Service Bulletin

Bulletin No.: 09-07-30-004F

Subject: Slips in Reverse or Third, Delayed Reverse or Drive Engagement, DTC P0776, P2715, P2723, Harsh 2-3 Shifts (Inspect 1-2-3-4 / 3-5-R Housing and Pump Seal Rings)

2715381

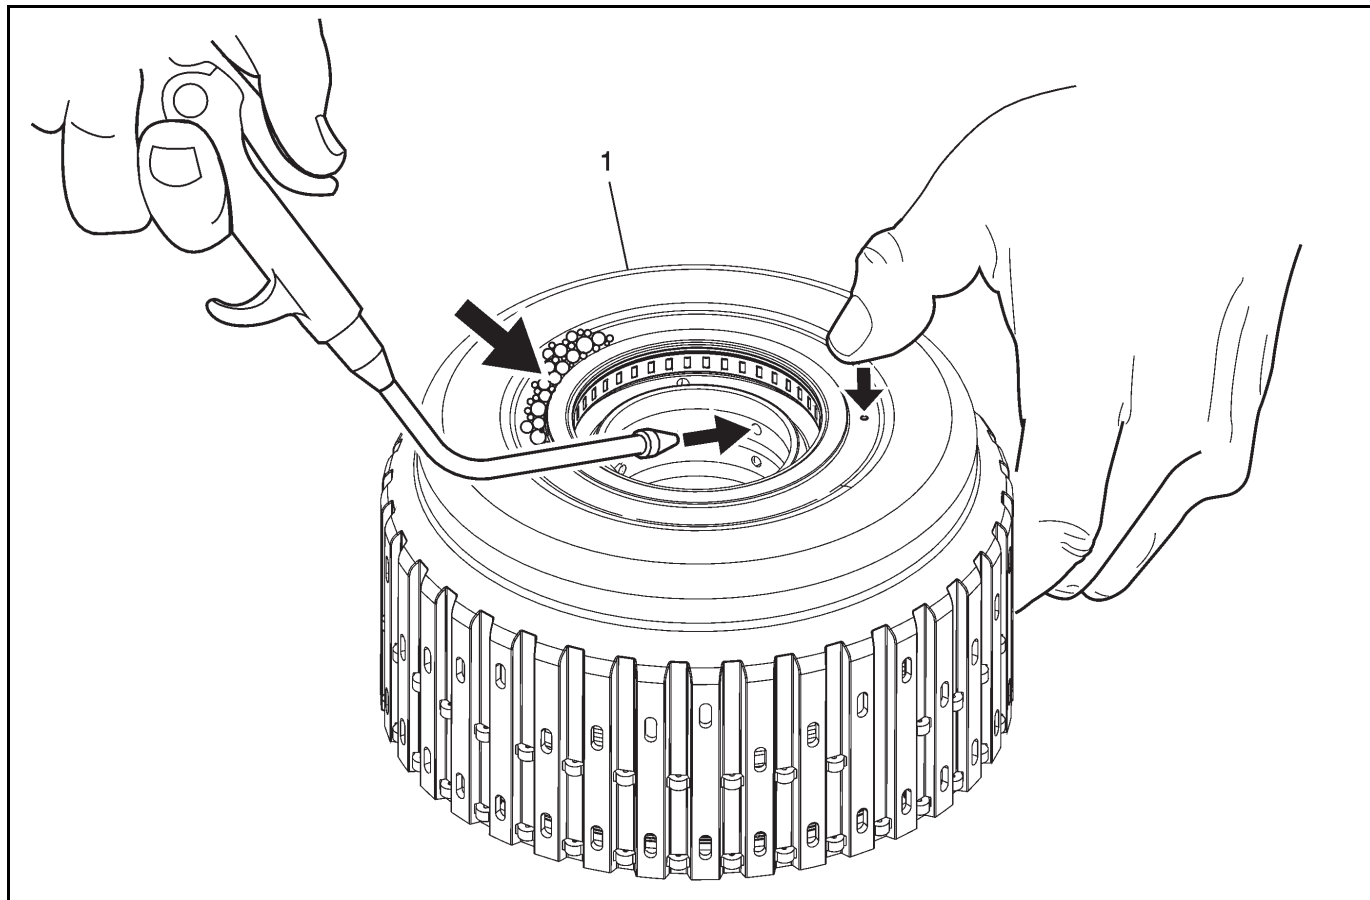
Inspect the 1-2-3-4 / 3-5-R clutch housing for a possible cracked weld. The housing can be inspected either assembled or disassembled.

1. Apply soap compound to the weld area of the housing.
2. Hold your thumb over the air bleed passage.
3. For a fully assembled 1-2-3-4 and 3-5 reverse clutch housing, spray compressed air into the 3-5R clutch feed hole and inspect the weld area for bubbles.
4. If bubbles are detected, a new housing is required.

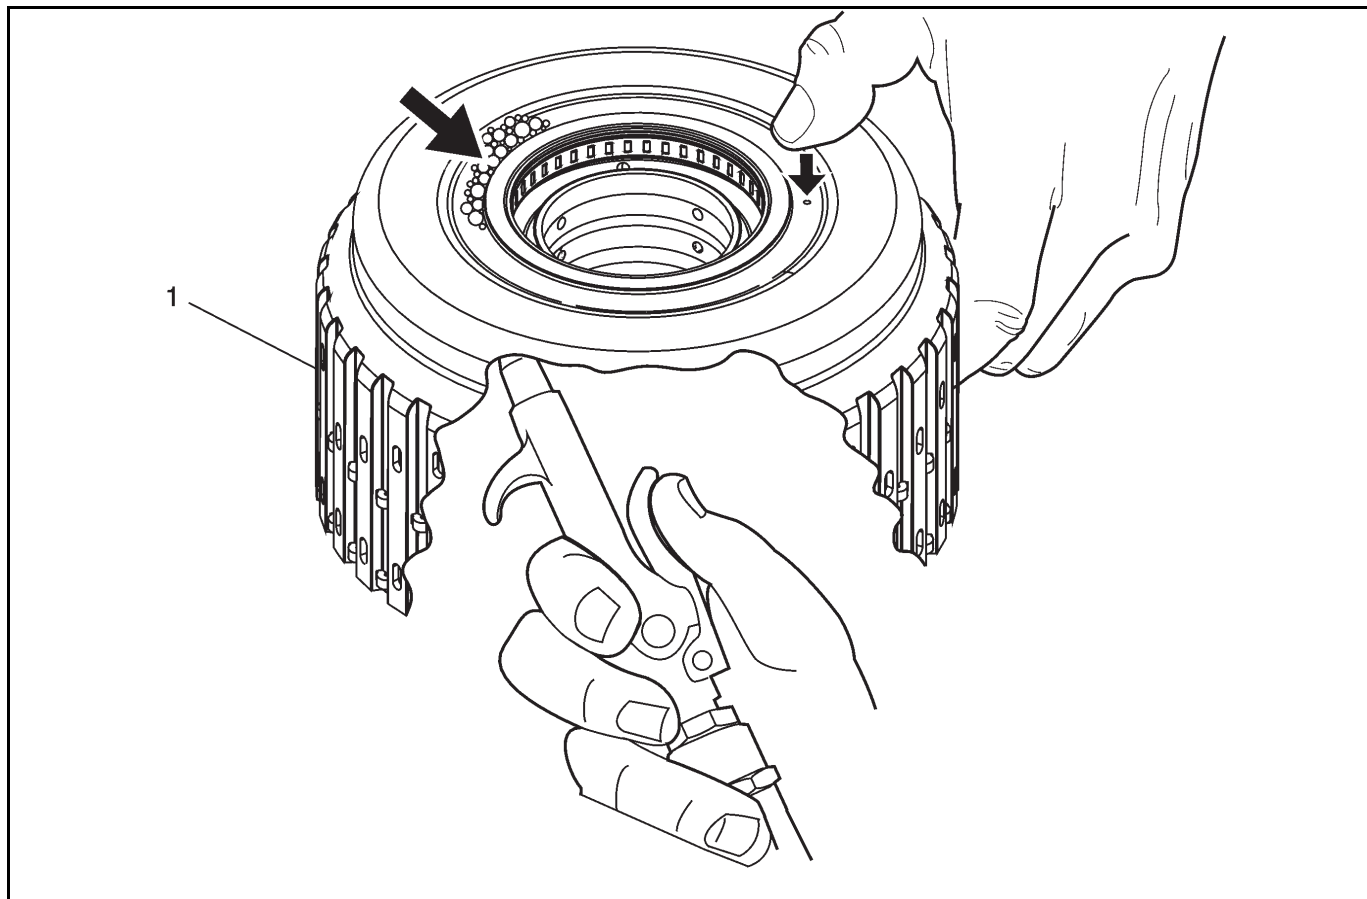
Inspect the 1-2-3-4 / 3-5-R clutch housing for a possible cracked weld.

1. Apply soap compound to weld area of the housing.
2. Hold your thumb over the air bleed passage.
3. Spray compressed air into the housing and inspect the weld area for bubbles.
4. If bubbles are detected, a new housing is required.

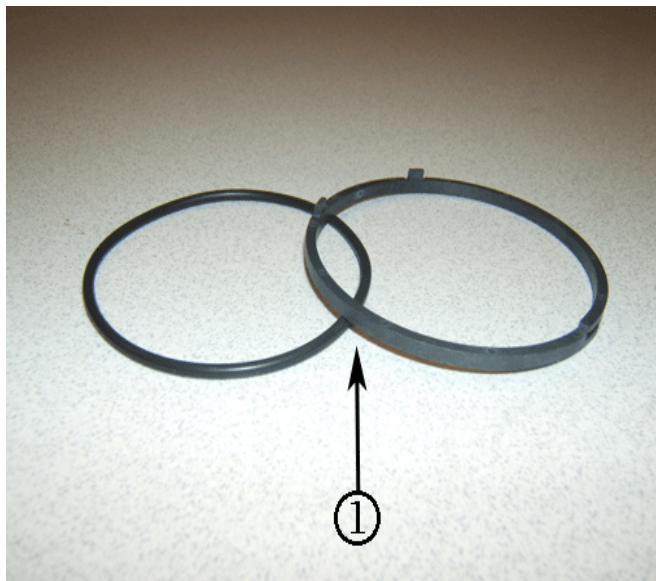
A harsh 2-3 shift condition may be caused by leaking 1-2-3-4 and 3-5-R clutch fluid seal rings (1) on the transmission fluid pump cover assembly.

Inspect the fluid seal rings. Transmissions in 2006, 2007, 2008 and early build 2009 models used a 1- piece design seal ring in production. Starting December 2008, a 2-piece seal ring design was implemented. The 1-piece seal ring design may cause

a harsh 2-3 shift due to leakage. This is typically a low mileage issue. If the seal rings are a 1-piece design they should be replaced.

If the seals are the 2-piece design shown below they do not need to be replaced unless they are worn or damaged.

Important: Do not install 1-piece design seal rings on a 2-piece seal ring design pump cover. The 2-piece seal ring design pump cover can be identified by the notches in the seal ring grooves that accept the tabs on the 2-piece design seal rings.

Notice: The three clutch fluid seal rings are required to be installed in a specific way. Failure to install new clutch fluid seal rings in the proper orientation may cause a repeat harsh 2-3 shift. Refer to 1-2-3-4 and 3-5 Reverse Clutch Fluid Seal Ring Installation (6L80/90) in SI for correct installation.
